BUILDING CODE OF AUSTRALIA COMPLIANCE ASSESSMENT REPORT

RESIDENTIAL DEVELOPMENT

61-65 LUCAS AVENUE, MOOREBANK

REPORT NO. ► PROJECT # 6672- REV 3.0

1 ELEVATION-1 TOWER -1 (LUCAS AV.)
SCALE 1:200

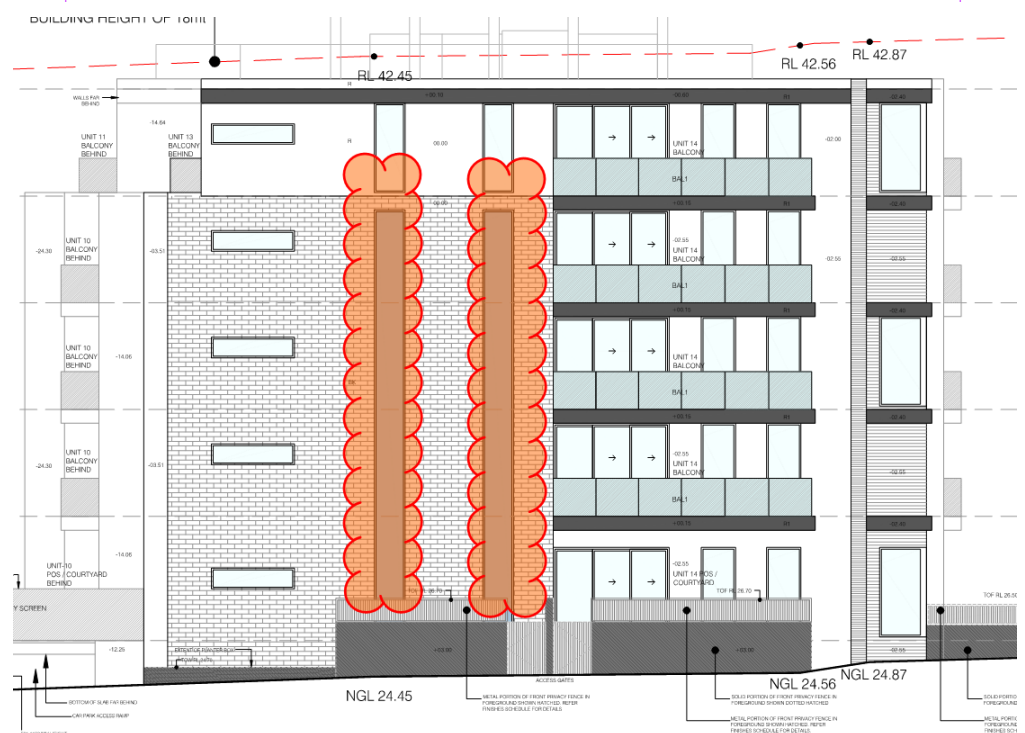
BCA Clause	Deemed-to-Satisfy Provision to be addressed
C2.6 Vertical Separation of openings in external walls	<p>There are several openings which require compliant spandrel separation to be provided (see examples below). In these examples, a horizontal spandrel extending a minimum 450mm beyond the opening (offset 450mm from the edge of the balconies) has not been provided. Where a panel wall (not less than 900mm in height, not less than 600mm above the upper surface of the intervening floor and non-combustible with an FRL of not less than 60/60/60) is to be used, the architect is to detail this on the plans at CC stage.</p> <p>Vertical spandrel separation is not detailed on all elevations. Examples of such areas are highlighted in orange below.</p> <p>Levels 01 – 03</p>

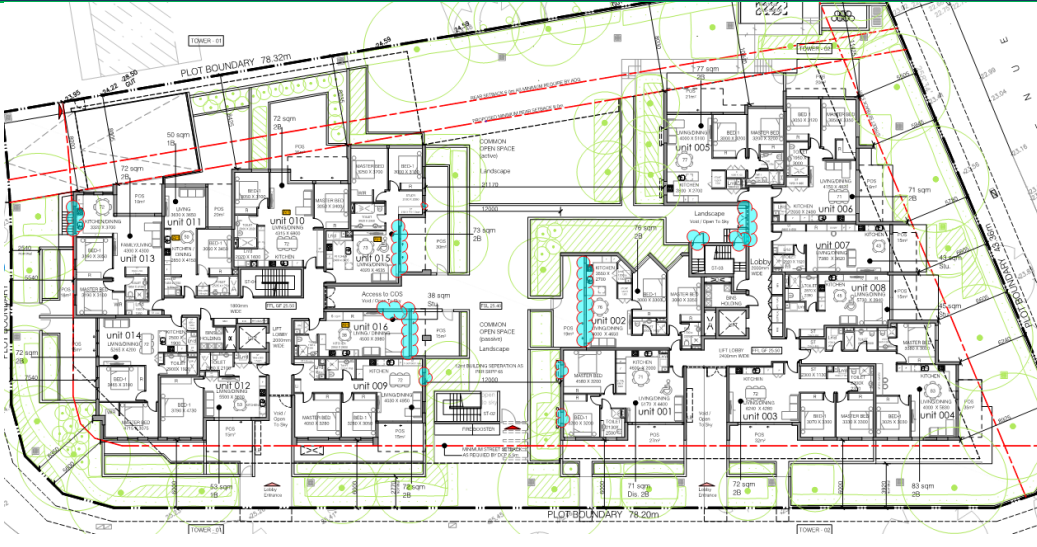
D1.6 Dimensions of Exits and paths of Travel to Exits	Stairway ST-01 is less than 1m wide (956mm noted).
D1.7 Travel via Fire Isolated Stairs	<ul style="list-style-type: none"> Stairways 01 and 04 do not provide independent egress into a fire-isolated passageway. Stairways 01 and 04 converge at carpark level 01. Stairways 03 serving the carpark levels and stairways serving the residential levels do not provide independent egress into a fire-isolated passageway. The stairways converge at ground floor. The path of travel to the road following discharge from fire stairs along the eastern side of the allotment on ground floor level will require occupants to pass at right angles and within 6m from the openings highlighted in blue below. <u>Ground floor</u>

2 ELEVATION-2 TOWER -1 (MCKAY AV.)
SCALE 1:200

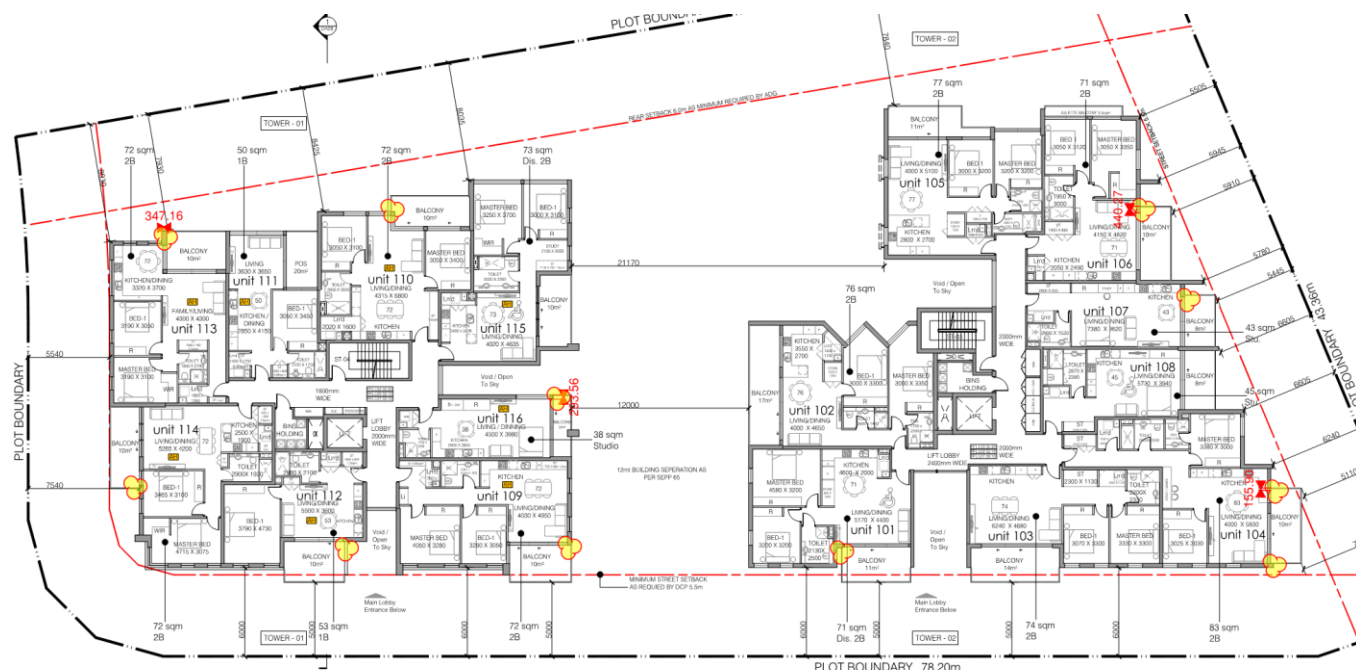
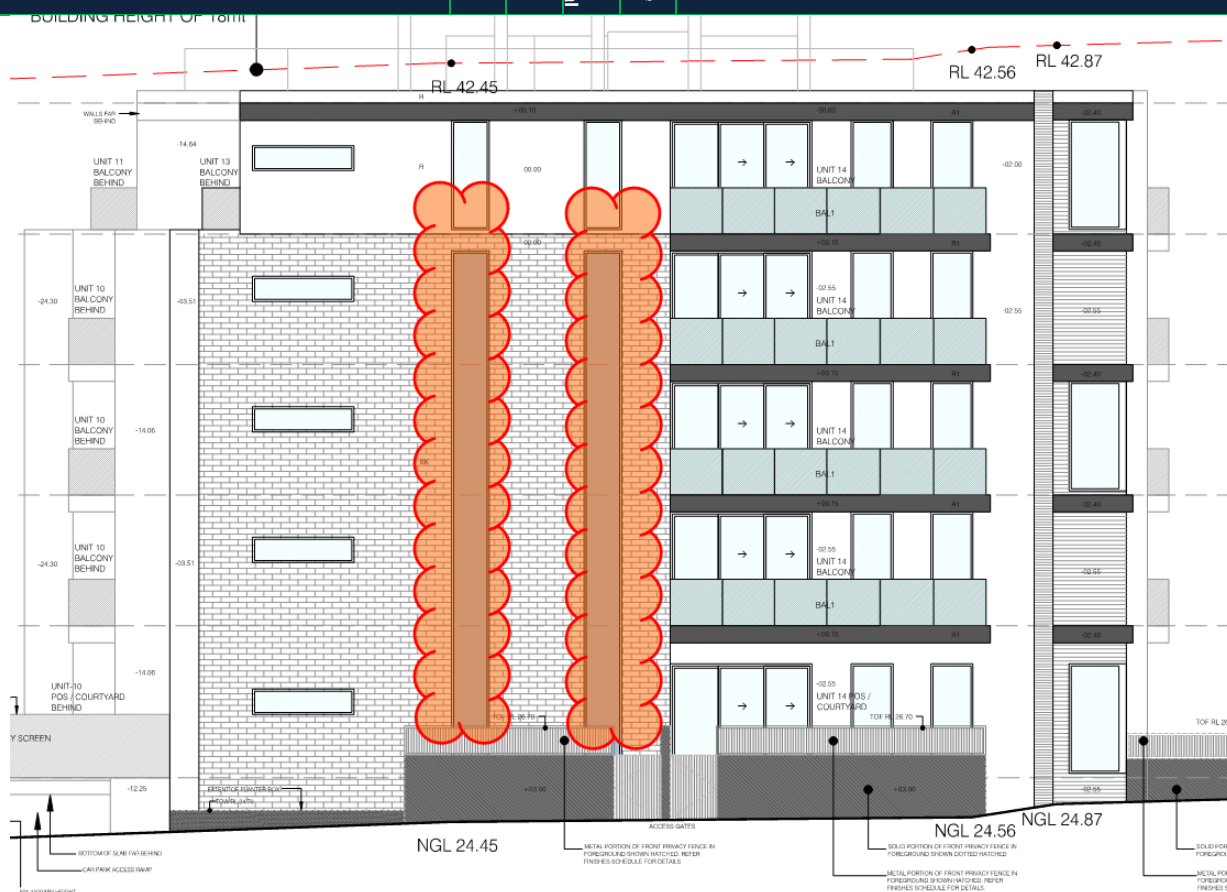
Levels 01 – 03

Ground floor

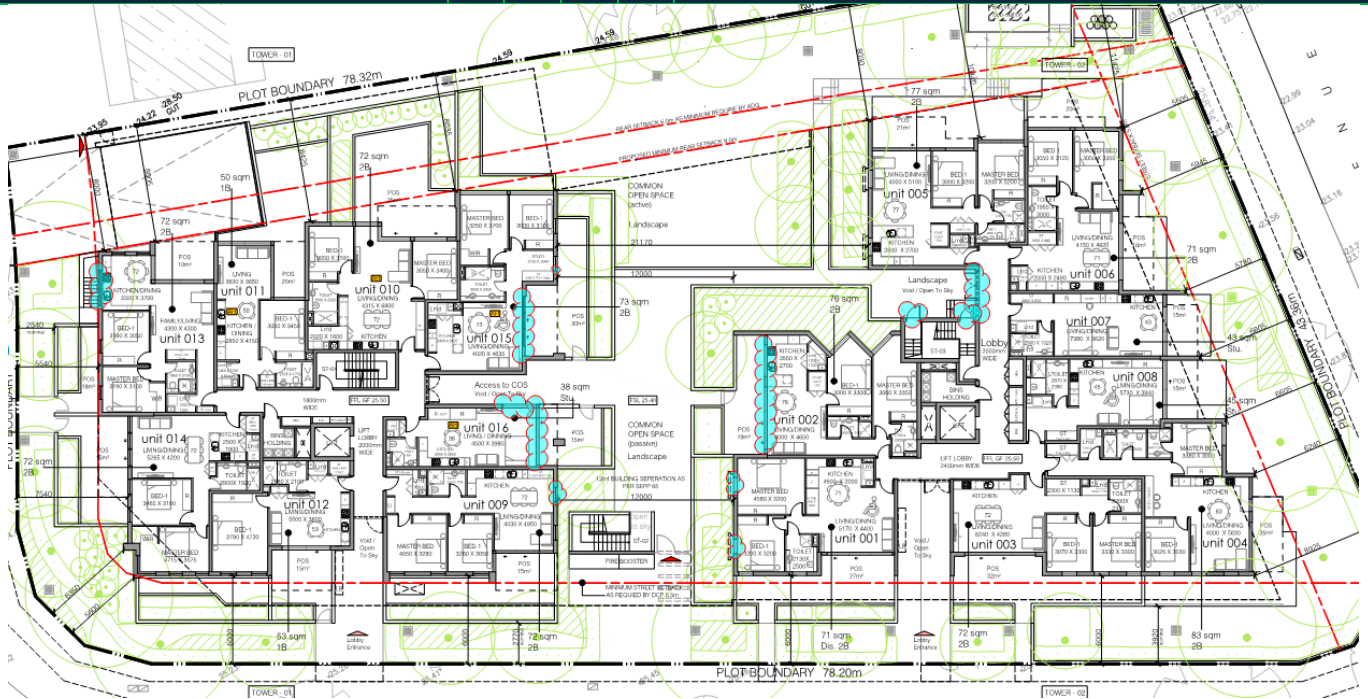
BCA DEEMED-TO-SATISFY PROVISION	COMPLIES	DOES NOT COMPLY	NA or Informational	Compliance Required	COMMENTS
					<p>(B) from which an unimpeded path of travel, not further than 20 m, is available to a road or open space; or</p> <p>(iii) into a covered area that—</p> <p>(A) (A) adjoins a road or open space;</p> <p>(B) and is open for at least 1/3 of its perimeter; and</p> <p>(C) has an unobstructed clear height throughout, including the perimeter openings, of not less than 3 m; and</p> <p>(D) provides an unimpeded path of travel from the point of discharge to the road or open space of not more than 6 m.</p> <p>(c) Where a path of travel from the point of discharge of a fire-isolated exit necessitates passing within 6 m of any part of an external wall of the same building, measured horizontally at right angles to the path of travel, that part of the wall must have—</p> <p>(i) an FRL of not less than 60/60/60; and</p> <p>(ii) any openings protected internally in accordance with C3.4,</p> <p>for a distance of 3 m above or below, as appropriate, the level of the path of travel, or for the height of the wall, whichever is the lesser.</p> <p><i>Details demonstrating compliance with this clause must be incorporated into the construction certificate plans / specification</i></p>
